DAUPHIN COUNTY SUBDIVISION/LAND DEVELOPMENT REVIEW REPORT

Plat Title: Northern Dauphin Christian School Land Development

Project Description: Purpose of the plan is to propose a school building and athletic field. The plan also proposes access drives, parking, utilities and associated stormwater management facilities.

1. THE PROPOSED SCHOOL BUILDING WILL BE SUBJECT TO THE ELIZABETHVILLE AREA AUTHORITY TAPPING FEE AND INSPECTION FEES IN EFFECT AT THE TIME OF APPLICATION FOR CONNECTION.

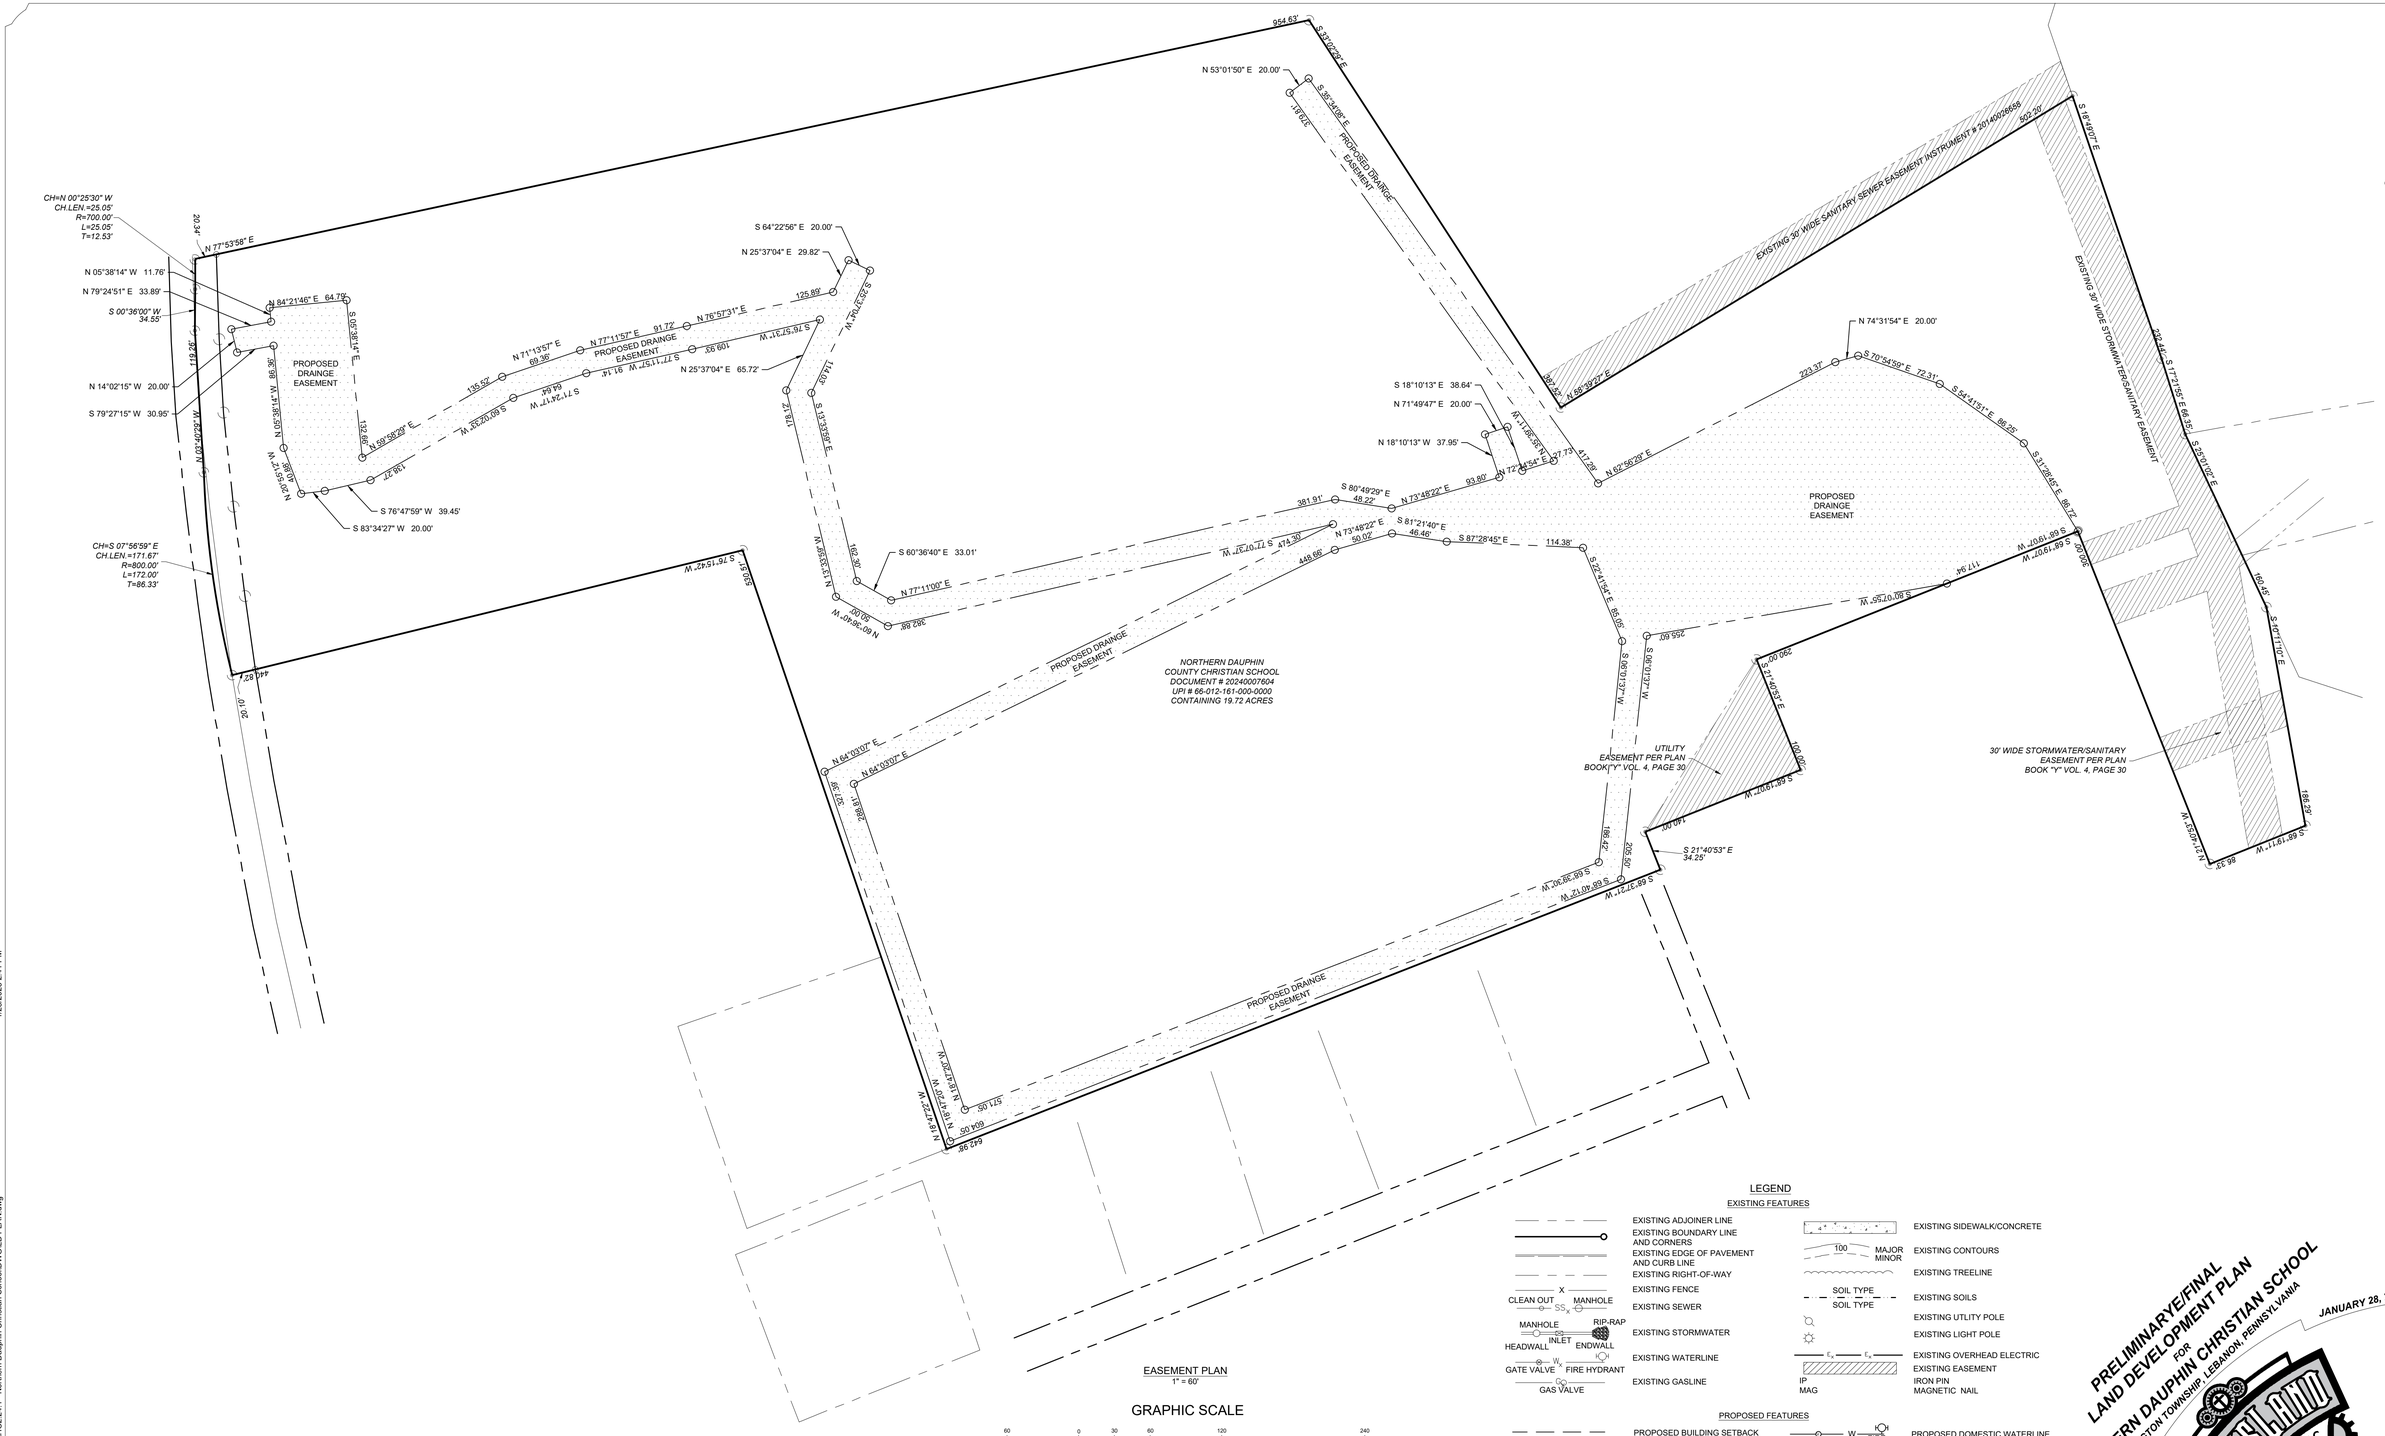
8) Harvest View Road infringes on the proposed development property. It is shown there is an easement in the area associated with the street, but it is identified as an "Utility Easement". It should be confirmed that this easement also allows vehicular traffic. It may be a prudent time to adjust such an easement if this is not in place.
